SFMTA - TASC SUMMARY SHEET

<p>PreStaff_Date: 4/1/2025</p> <p>Requested_by: SFPW-BSM</p> <p>Handled: Edward Tang, 646-2064</p> <p>Section Head : <i>[Signature]</i></p>	<p><input type="checkbox"/> Public Hearing Consent</p> <p><input checked="" type="checkbox"/> Public Hearing Regular</p> <p><input type="checkbox"/> Informational / Other PH - Consent</p>	<p>No objections: _____</p> <p>Item Held: _____</p> <p>Other: _____</p>
<p>Location: Connecticut Street between Cesar Chavez and 26th Street</p>		
<p>Subject: Parallel Parking</p>		
<p>PROPOSAL / REQUEST: RESCIND – PERPENDICULAR PARKING ESTABLISH – PARALLEL PARKING Connecticut Street, west side, from 129 feet to 165 feet south of 26th Street (Supervisor District 10)</p> <p>Proposal to convert perpendicular parking to parallel parking due to sidewalk construction at 1920 Cesar Chavez.</p> <p>This item was previously heard at the May 2, 2025 Engineering Public Hearing and has been revised to shorten the length of the perpendicular to parallel parking conversion due to opposition at that hearing. SFFD concurred with the shorter length, and this proposal is being brought back to the June 6, 2025 Engineering Public Hearing.</p> <p>Edward

Attachment 2

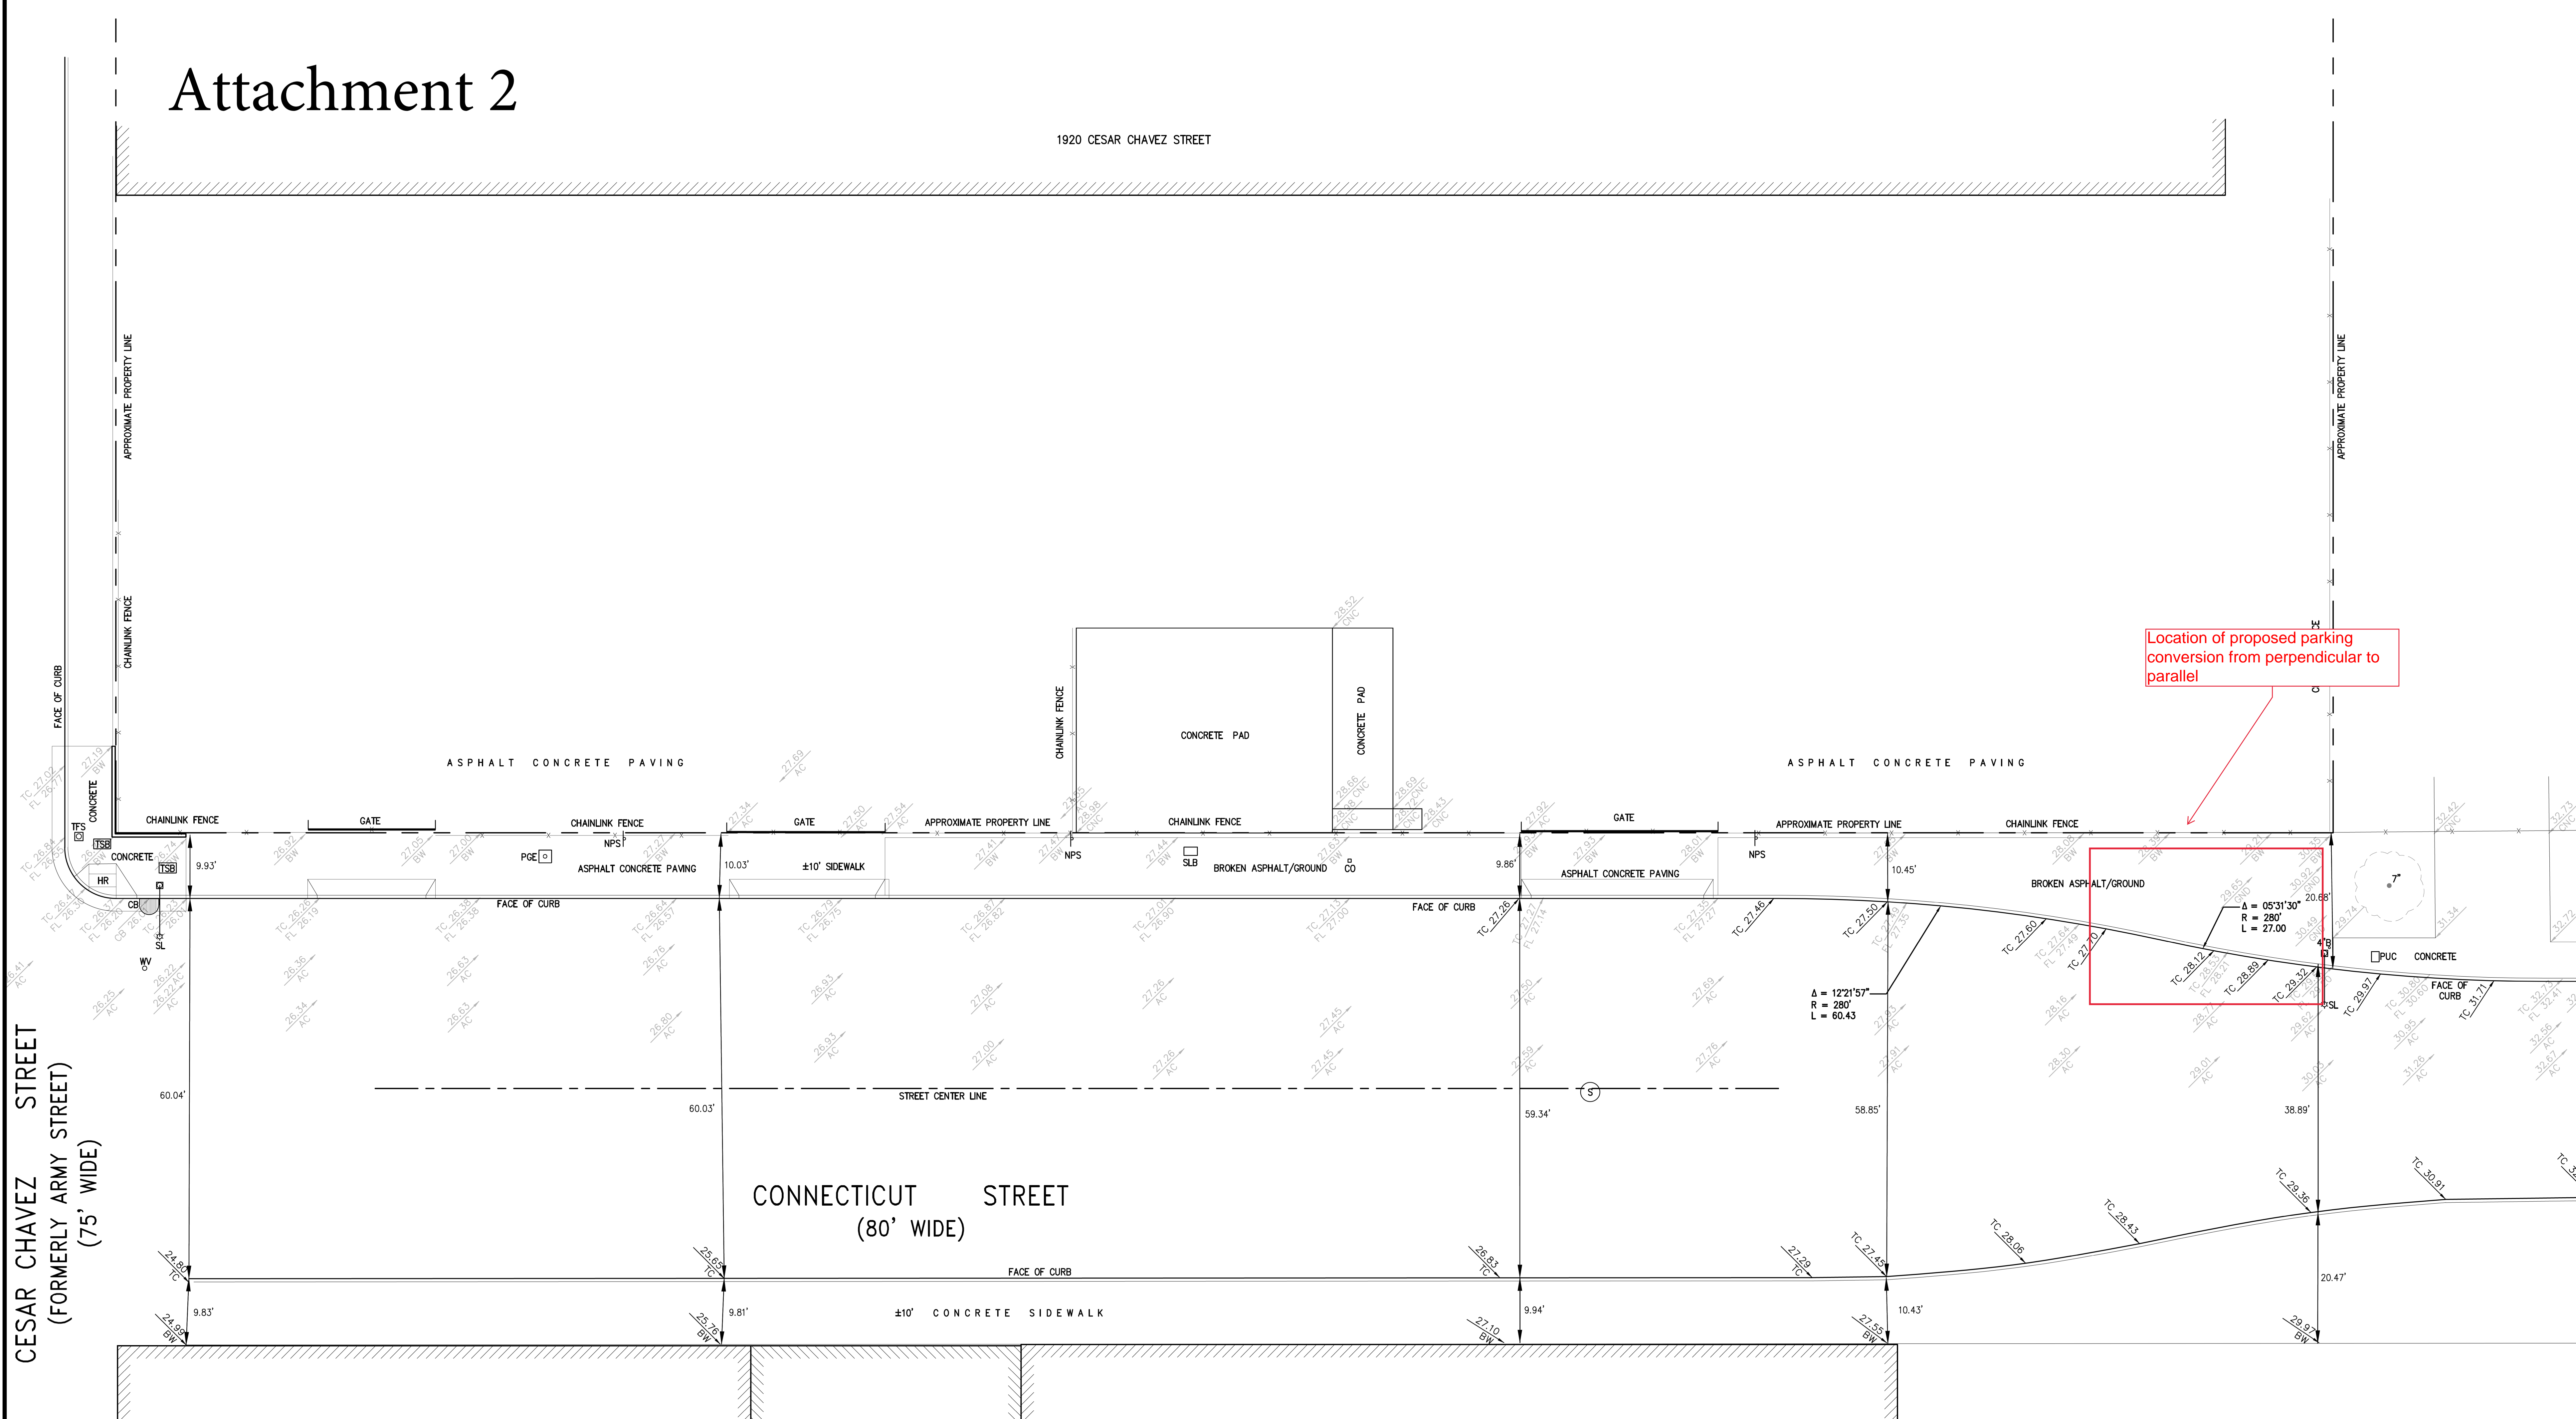
After further internal discussion and coordination with SFFD, our recommendation for item #8 is to reduce the proposed perpendicular to parallel parking conversion length by 30 feet. This proposal would retain additional parking capacity (net loss of approx. 2 spaces instead of 4) for the street and is acceptable to SFFD per the attached email.

We have NO OBJECTIONS to the 3 north most parking spots remaining parallel.

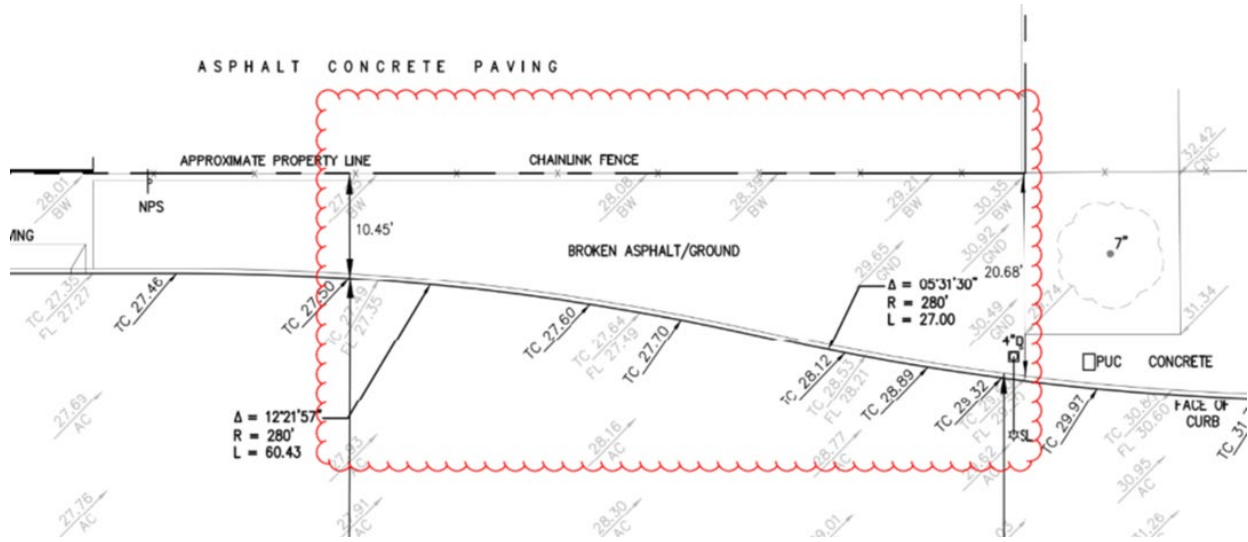
- Connecticut Street: Please confirm that SF Fire has reviewed these plans and approve of the minimum roadway width in the red area below, where the sidewalk widens. If cars continue to park 90-degrees in the red area, this would result in vehicles protruding more into the roadway than existing conditions. If they need more clear width, we will need to legislate the parking to be converted from 90 degrees to parallel. Note: the 90-degree parking, south of this section, will work fine since the roadway is wider from the 10.45' dimension to Cesar Chavez.

Thank you for bringing this to my attention. No, the parking in the red bubble would need to be converted.
